August 18, 2023

**SUBJECT: REVIEW OF BIOLOGICAL RESOURCE ISSUES
RECIRCULATED DEIR, COTTONWOOD SAND MINE PROJECT
COUNTY OF SAN DIEGO, CALIFORNIA**

Comments on Cottonwood Sand Mine Recirculated DEIR
August 18, 2023

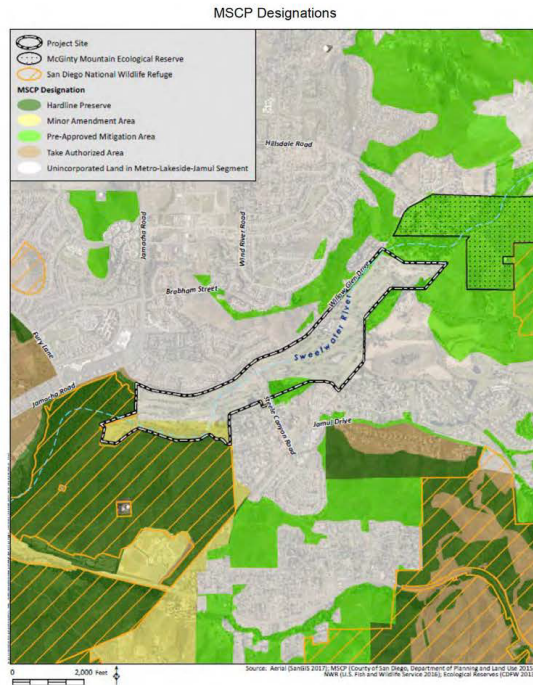
BRCA. The northeastern two-thirds of the project site consists of the still-active Ivanhoe golf course and the remainder of the site consists of the disused Lakes Course. Given these designations, the site has an important strategic role in the function of the South County Subarea MSCP. An exhibit entitled "MSCP Designations," provided on the last page of the County's MSCP Findings of Conformance Statement and reproduced below, indicates the importance of this site in the regional open space system.

Figure 1. Reproduction of the "MSCP Designations" exhibit provided on the final (un-numbered) page of the County's MSCP Findings of Conformance Statement. As shown, the project site represents the only viable habitat linkage between the San Diego National Wildlife Refuge in the southwest and the McGinty Mountain Ecological Reserve in the northeast.

R-07-37 This comment presents information related to the Project's various MSCP designations, which are presented in Section 2.2.1.1 of the RDEIR and 1.4.1 of the Biological Resources Technical Report recirculated with the RDEIR (FEIR and RDEIR Appendix C) and depicted on Figures 2.2-1 and 2.2-6 of the RDEIR and Figures 4 and 14 of the Biological Resources Technical Report. This comment does not raise an issue concerning the environmental analysis or adequacy of the RDEIR. Please also see Response to Comment R-07-3.

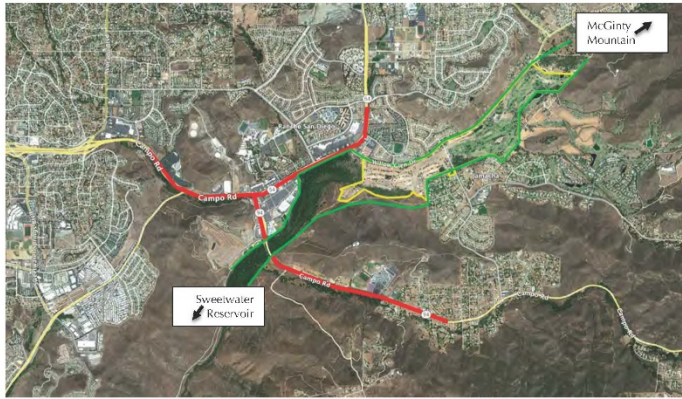
Figure 2. Aerial imagery, without the screens used in Figure 1, showing even more clearly that urban development along Highway 94 and Highway 54 effectively blocks nearly all movement of terrestrial and aquatic wildlife between Sweetwater Reservoir/SDNWR and the McGinty Mountain Ecological Reserve. The project site, an MSCP-designated habitat linkage containing a river channel, provides by far the most viable opportunity for terrestrial and aquatic wildlife to move through this highly fragmented landscape.

Photo 12. View, facing northeast, showing healthy Southern Willow Scrub in the channel of the Sweetwater River. The RDEIR misclassifies this habitat as Disturbed Wetland.

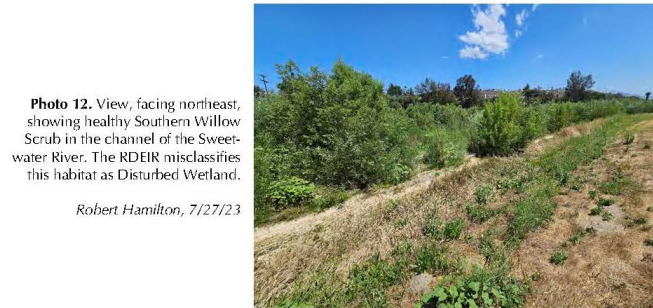
The following site photos (nos. 9, 10, 12, 13, 16, and 17) show several areas of healthy Southern Willow Scrub, all misclassified as Disturbed Wetland. Despite the logical presumption that heavy rains in 2022/2023 would have substantially altered and improved habitat conditions in the Sweetwater River channel, the County chose not to review the old vegetation mapping for accuracy. As a result, the RDEIR misrepresents the existing conditions in the river channel. Furthermore, the RDEIR fails to note that establishment of a ribbon of Southern Willow Scrub habitat through the middle of the site has improved the existing opportunities for wildlife movement through the site, as well as improving/expanding suitable habitat for such species as the Arroyo Toad, Western Spadefoot, and Least Bell's Vireo, none of which were surveyed for in 2023. For these reasons, the RDEIR's characterization of the site's riparian resources is inaccurate, inequitable, and unreliable.

R-07-38 Please see Response to Comment R-07-13 for a discussion on habitat classification and mapping, as well as the classification of areas within the Project site as disturbed habitat. The commenter included site photos taken in July 2023. While successional growth of willows in select areas was observed, along with presence of Bermuda turf grass that naturalized following abandonment of the golf course, the presence of these species does not require the continued updating of the baseline condition, which has already been established. Regarding habitat mitigation necessary to reduce impacts to California glossy snakes, western spadefoot, and other sensitive species, the EIR includes several mitigation measures that reduce the potential for impacts to these species to less than significant. The comment does not express whether or upon what grounds the commenter believes these mitigation measures to be inadequate. While impacts to disturbed habitat do not require mitigation, the Project's proposed habitat restoration exceeds the overall habitat mitigation requirements, such that the impacts to 76.1 acres of disturbed successional habitat within abandoned golf course areas would be offset by the overall habitat restoration. An additional 29.9 acres of habitat preservation also would occur, for a total of 150.7 acres of on-site BOS that would connect preserved areas up- and downstream of the site. The Project's on-site native habitat restoration and revegetation would provide higher quality habitat than currently exhibited by the active and abandoned golf course.

R-07-43 Please see Response to Comment R-07-13 for a discussion on habitat classification and mapping, and Response to Comment R-07-15 for discussion related to biological surveys conducted for the Project and analysis of Project impacts to special status species. The enclosed photos are addressed in Response to Comment R-07-38.
